DEVELOPMENT APPLICATION ASSESSMENT REPORT

Application Number:	DA2022/2049
----------------------------	-------------

Responsible Officer:	Adam Susko
Land to be developed (Address):	Lot 19 DP 14534, 12 Coonanga Road AVALON BEACH NSW 2107
Proposed Development:	Demolition works and construction of a dwelling house including swimming pool
Zoning:	R2 Low Density Residential
Development Permissible:	Yes
Existing Use Rights:	No
Consent Authority:	Northern Beaches Council
Land and Environment Court Action:	No
Owner:	Tracey Anne Squire Garry Donald Squire
Applicant:	Garry Donald Squire

Figure 2: ground floor plan depicted encroachments in the western 2.5m side boundary setback in red.

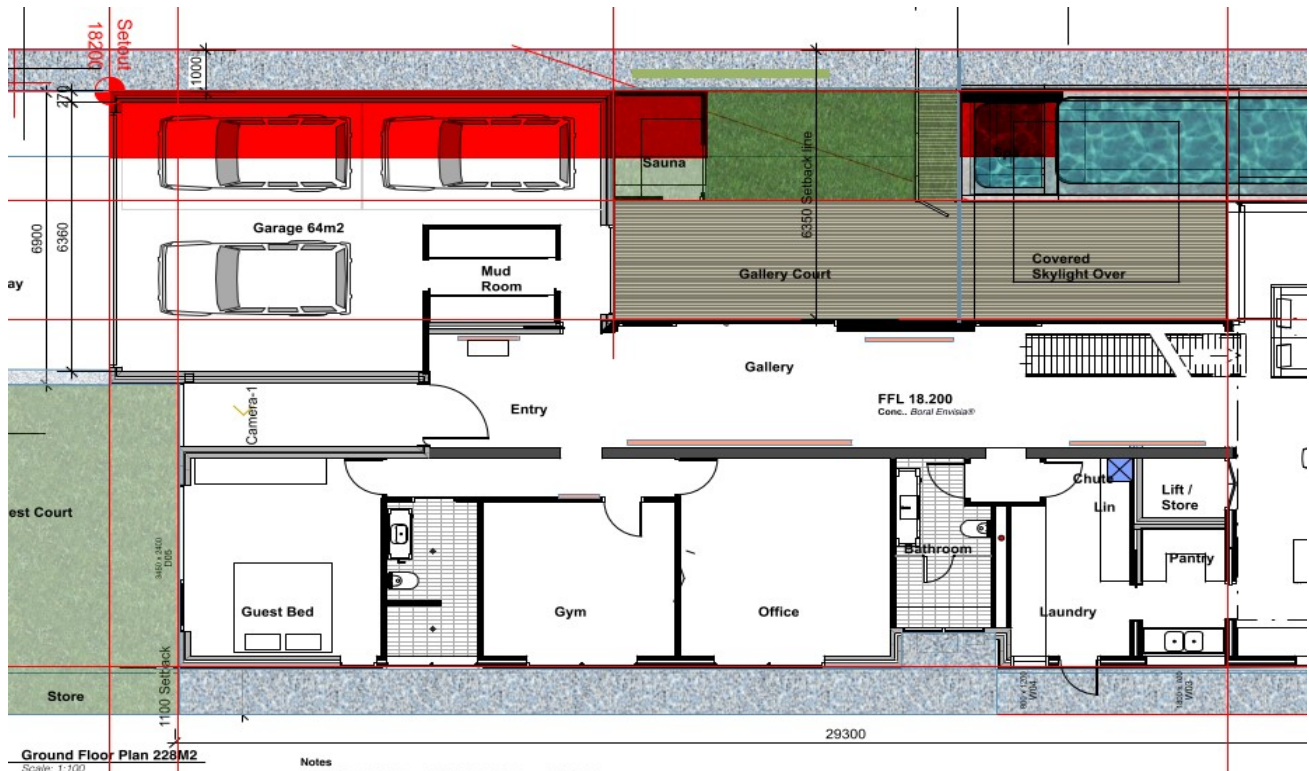
The garage, sauna and concrete roof structure overhanging the southern end of the swimming pool encroaches within the prescribed setback area by up to 60%. The extent of area encroaching the setback is depicted on the below working drawing in red.

The proposal seeks to construct approximately 20m² of floor area within the prescribed setback. The encroaching portions include a garage, sauna and concrete roof. Despite these encroachments, the positioning of the building is not incongruent with the established pattern of buildings, and is not reflective of an excessively sized building. To that extent, the proposal achieves consistency with the desired future character of the locality.

The encroaching elements are single storey and align with the building to the west. When view from the public domain and neighbouring properties, the setback of the building appears consistent with neighbours, and does not create any unreasonable bulk or scale.

The encroachment into the side setback area does not give rise to any unreasonable impacts on the amenity of neighbouring properties. For the most part, the western setback of the dwelling is significantly greater (4m+) than what the control requires.

On balance the non-compliance to the control requirements has been found to succeed against the control outcomes and accordingly, the variation as proposed may be supported.

Figure 3: working drawing of eastern elevation showing 0.3m high side boundary envelope encroachment.

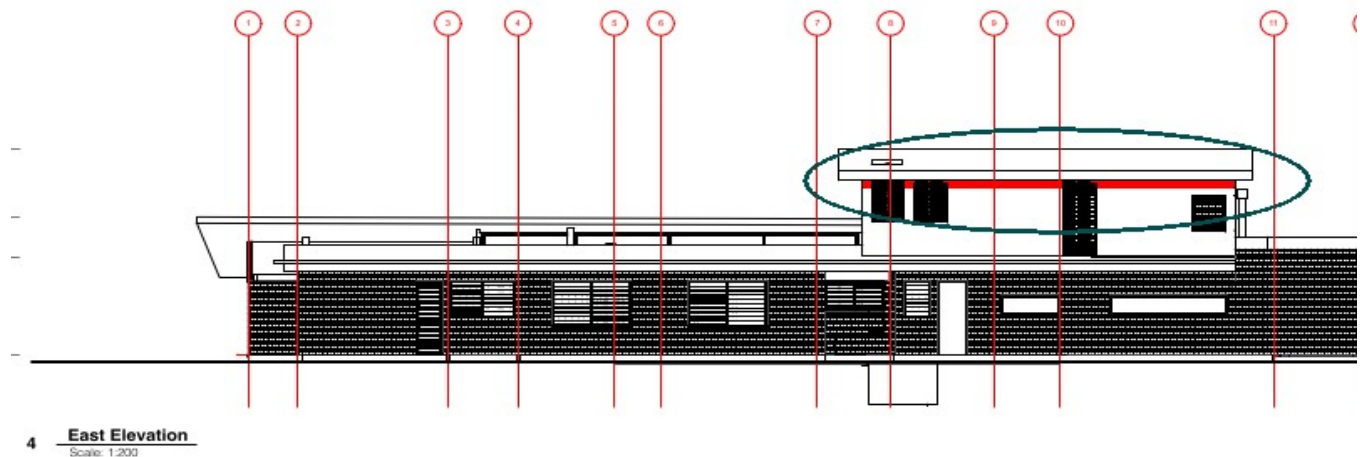
To the eastern elevation of the house the first floor addition projects outside of the envelope for the full width of the building and to a maximum height of 0.3m. The area of encroachment is highlighted in red on the below working drawing prepared by the author, and is circled for ease of reference.

The non-complying element of the building is not considered to cause any unreasonable visual bulk when viewed from neighbouring properties. The first floor element aligns with neighbouring houses and is not excessive in its proportions. Compliance could be achieved by shifting the first floor to the west by 300mm, however this would have a negligible benefit in terms of the bulk of the building when viewed from neighbouring homes. On balance, the bulk and scale is acceptable.

Having regard to the above assessment, it is concluded that the proposed development is consistent with the relevant outcomes of the P 21 DCP 2014 and the objectives specified in s1.3 of the Environmental Planning and Assessment Act 1979. Accordingly, this assessment finds that the proposal is supported, in this particular circumstance.
